ADDENDUM NO. 1: AFB – CITY OF CORTEZ

2026 SERVICE CENTER UPPER YARD FUEL DELIVERY SYSTEM DECOMMISSION

#GS-26-SCFD

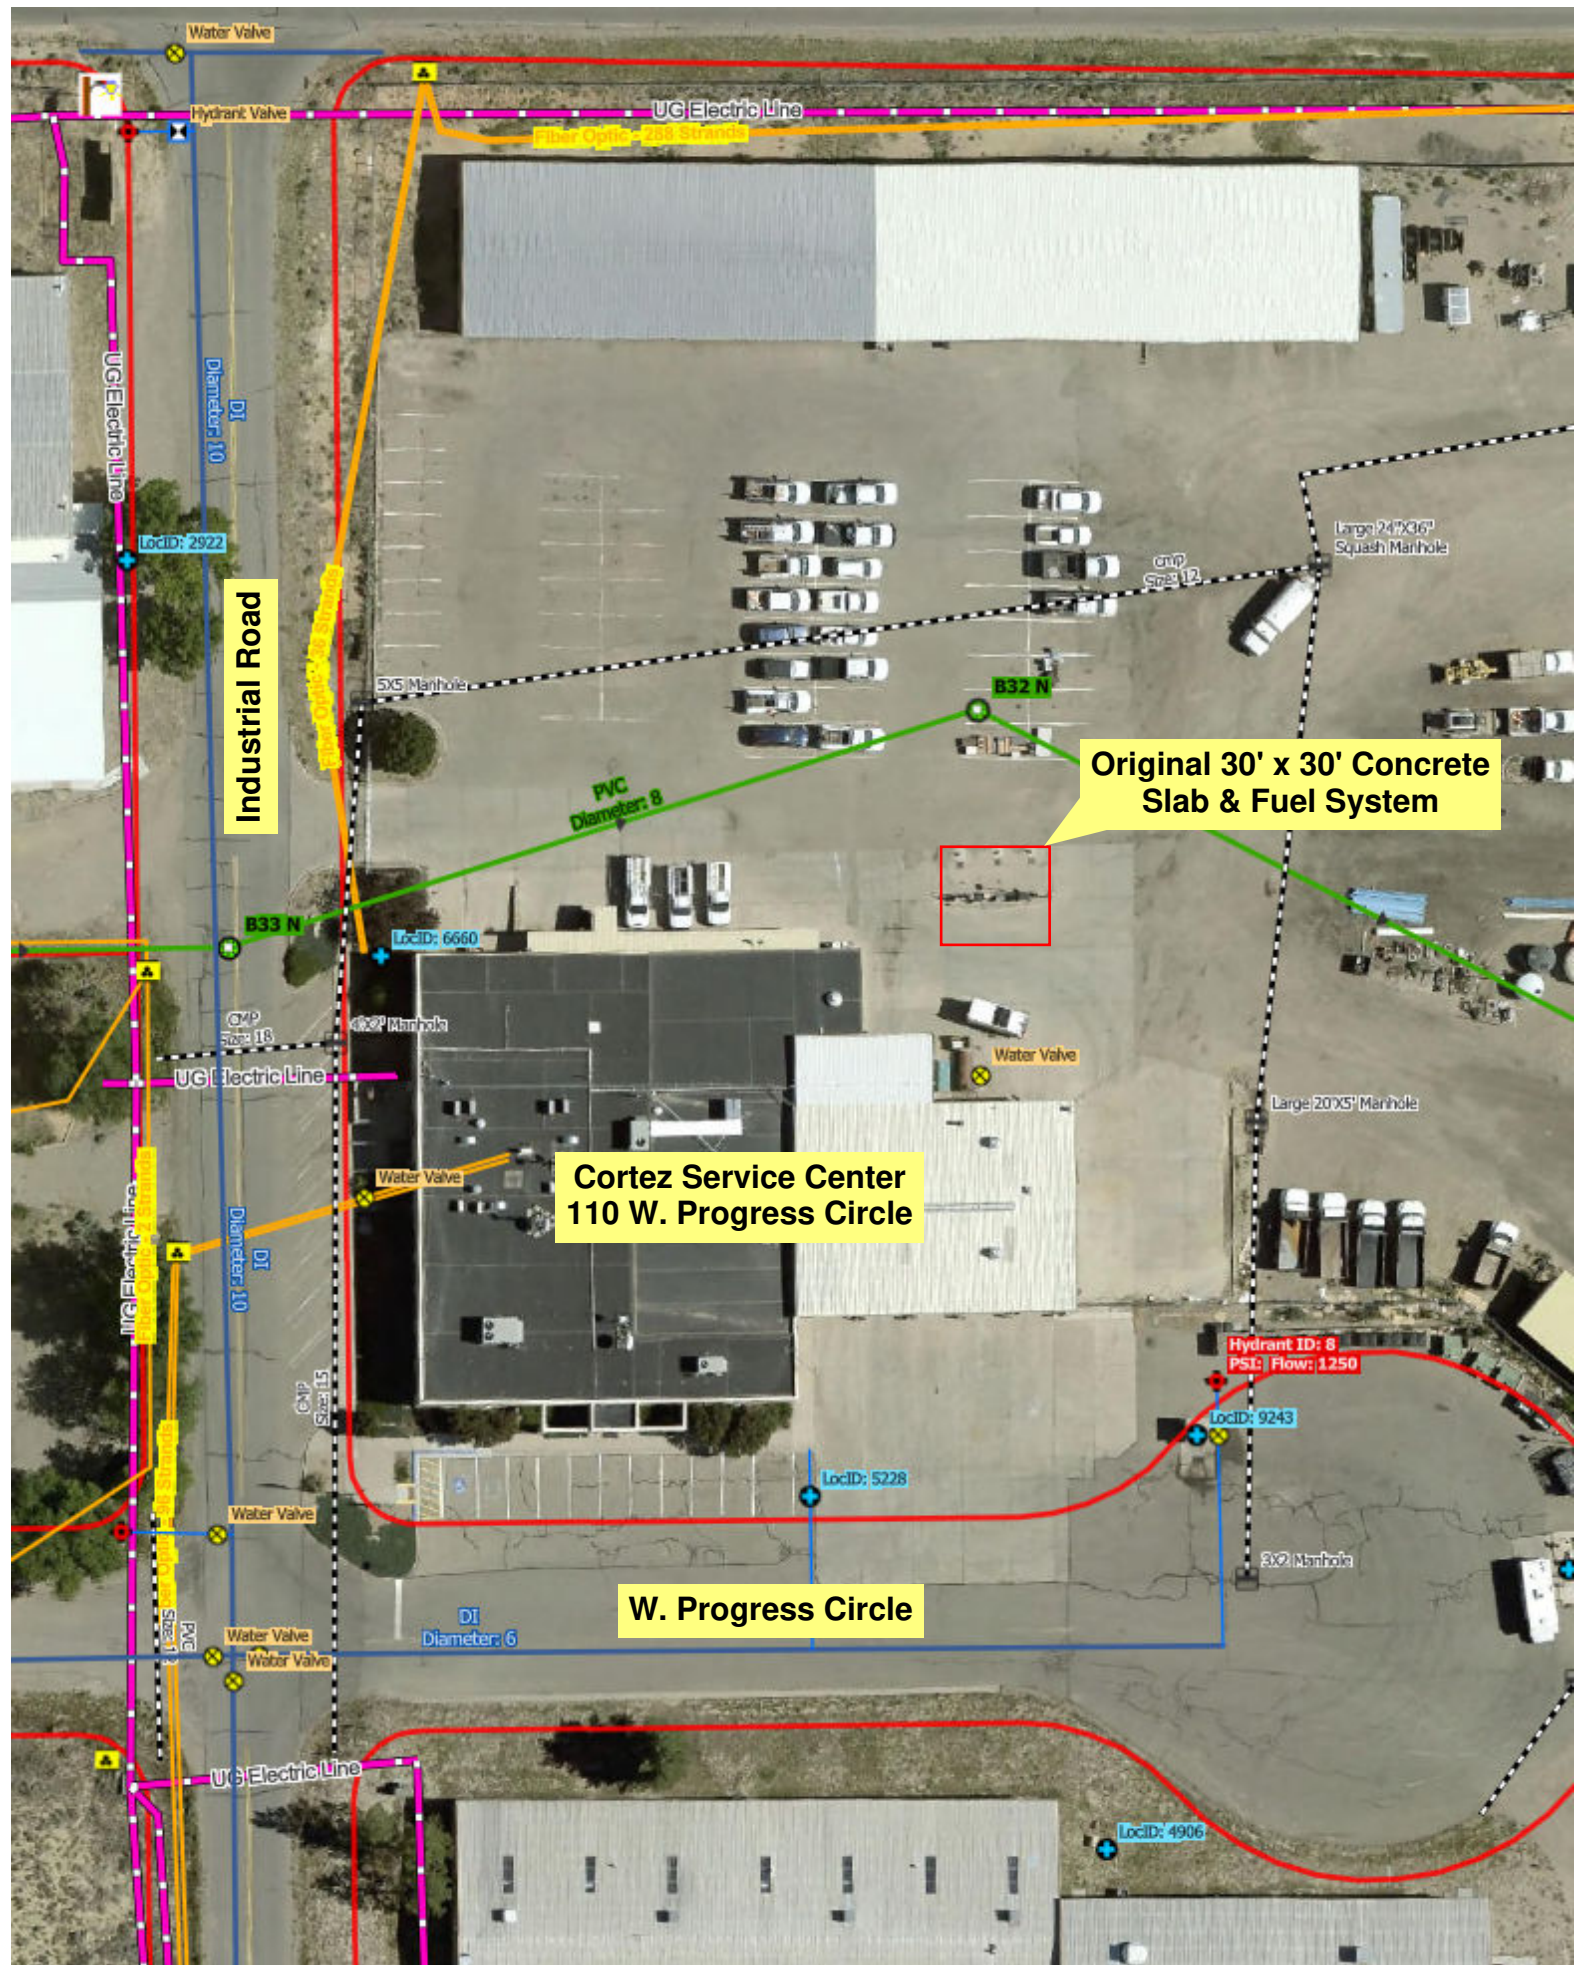
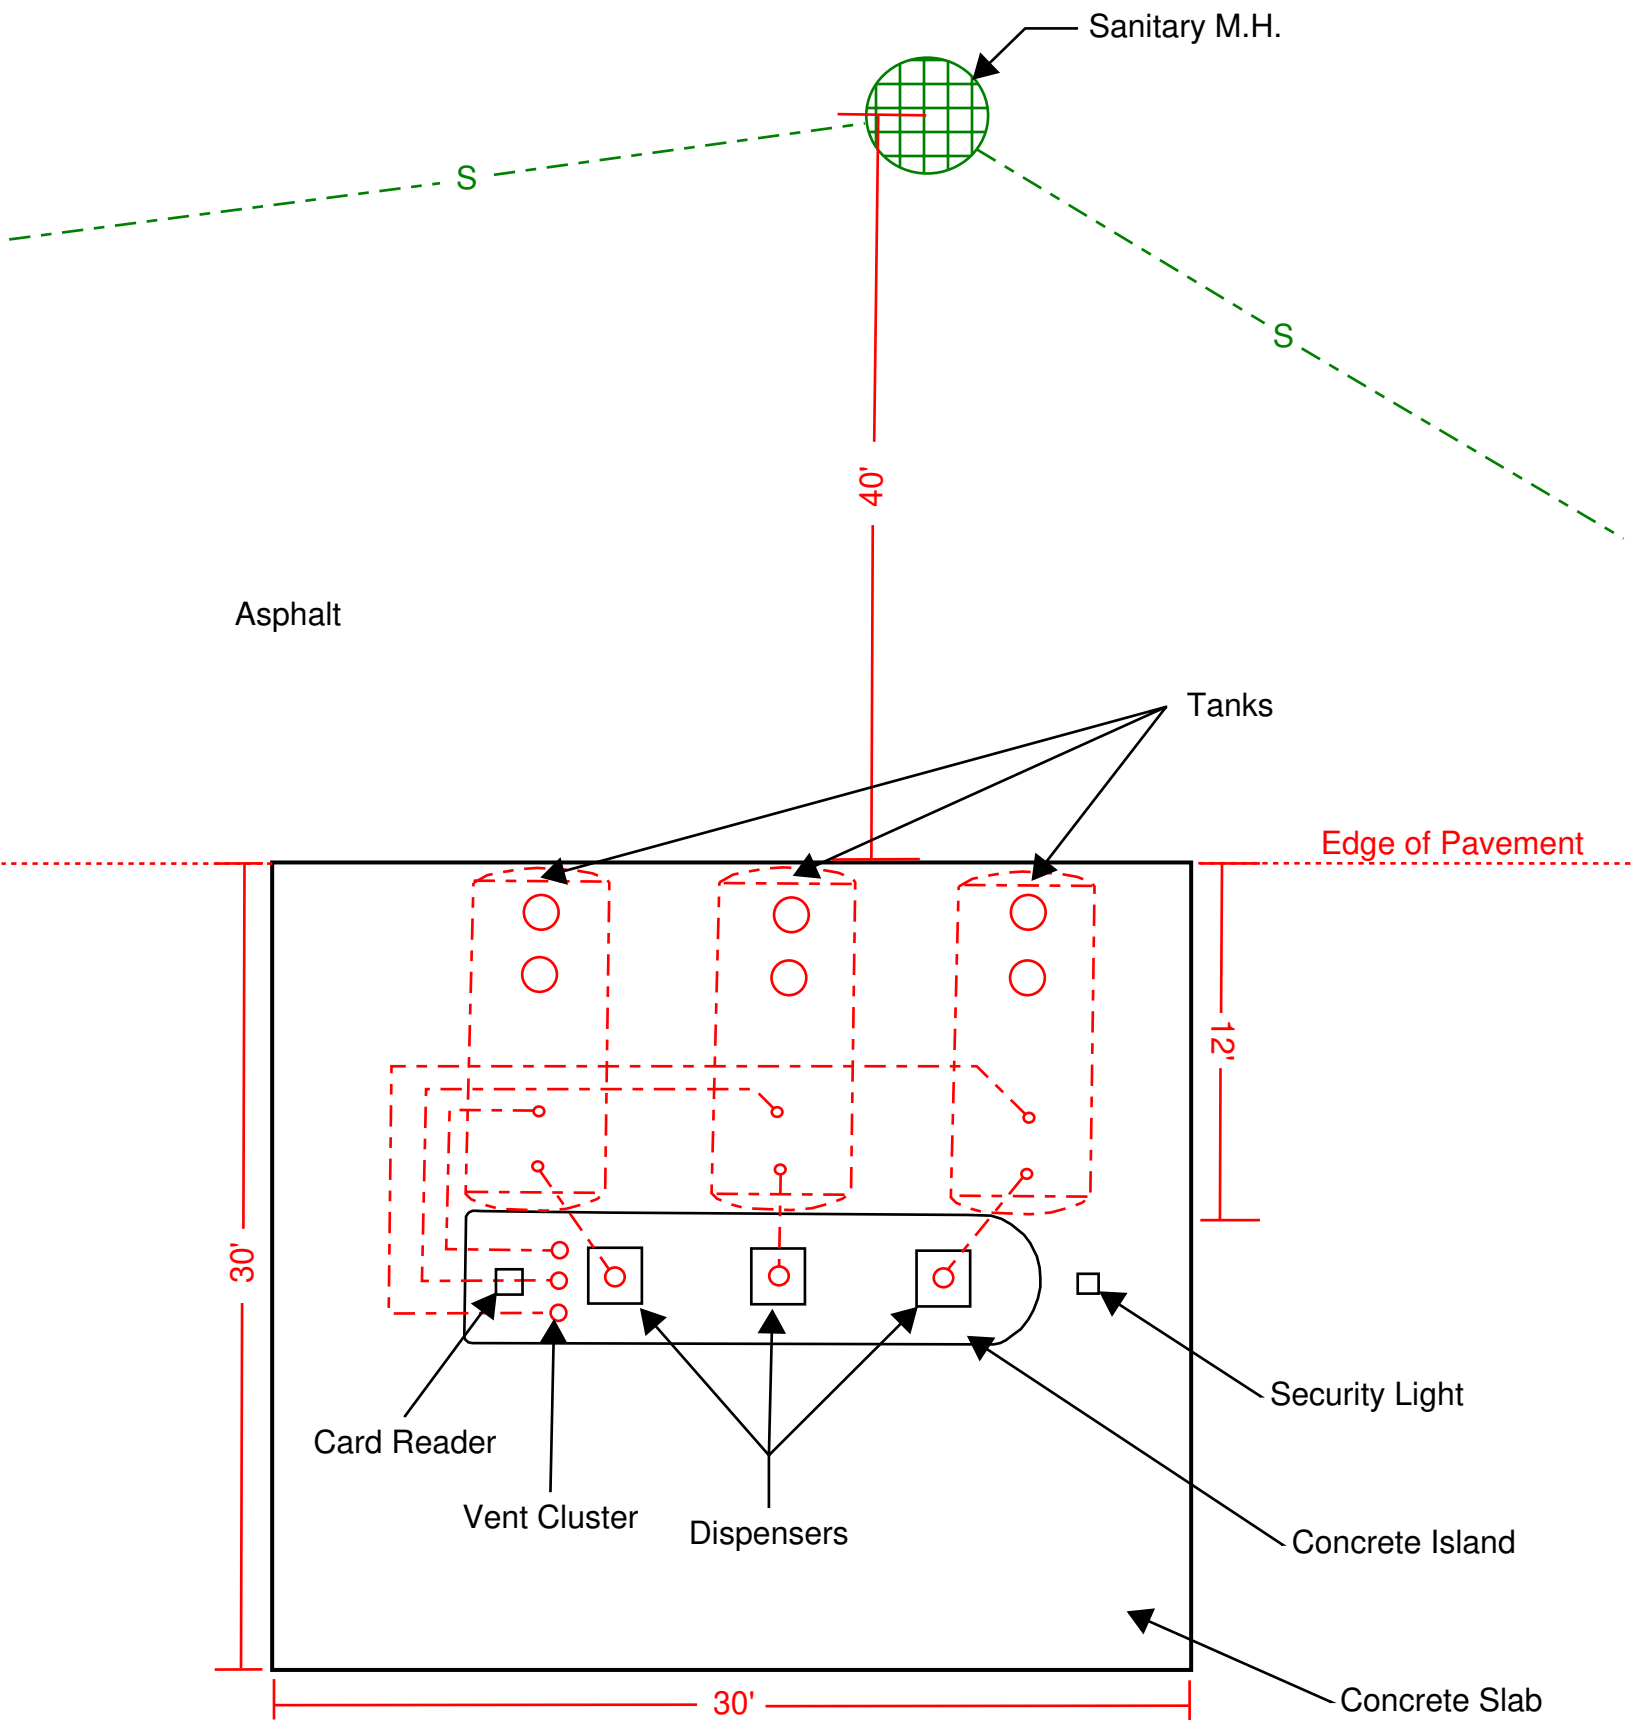
1. *Can the City provide as-built drawings or sketches of tank locations relative to dispensers, property lines, utilities, buildings, and other features/obstructions?*

- a. Please refer to the attachments below this addendum. The fuel system that is to be removed is completely located within the upper yard of the Cortez Service Center and is relatively isolated from any other utilities, buildings, or features/obstructions. Unfortunately, the City does not have any as-built drawings of the fuel delivery system due to its age. It is believed that the three (3) underground steel storage tanks are 2,000 gallons in capacity, measuring 12 feet in length and 64 inches in diameter, buried approximately 30 inches below the concrete slab in well-tamped sand or gravel backfill.

Surrounding Concrete

Fuel Tanks: 12' Long x 64" Diameter
 Tank Spacing (From Centerline): 11'
 Concrete Island: Apx. 27' Long x 3' Wide
 Closest Point to Building: Apx. 30'
